Interactive comment on “Development of the very long range muographic imaging technique to explore the internal structure of an erupting volcano, Shinmoe-dake, Japan” by T. Kusagaya and H. K. M. Tanaka

Received and published: 22 September 2015

Fig. 1.

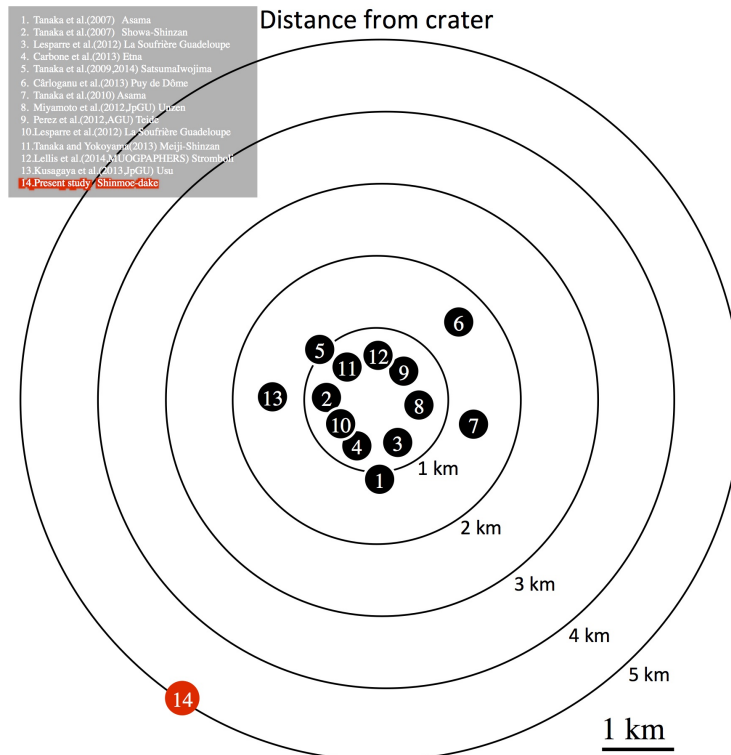
2. Page 3 line 43, Fig. 1 should be simplified by removing presently used volcano plane-map as a background.

→Fixed. Please see Fig.1.

Fig. 2.

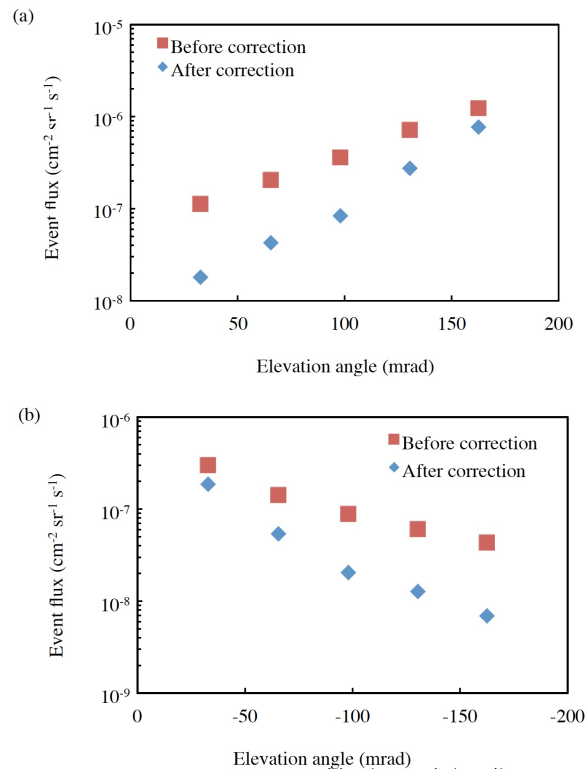
7. Page 47 Fig. 13 (b), Elevation angle (mrad) of horizontal axis should be negative values like -50, -100, etc.

→Fixed. Please see Fig.2.
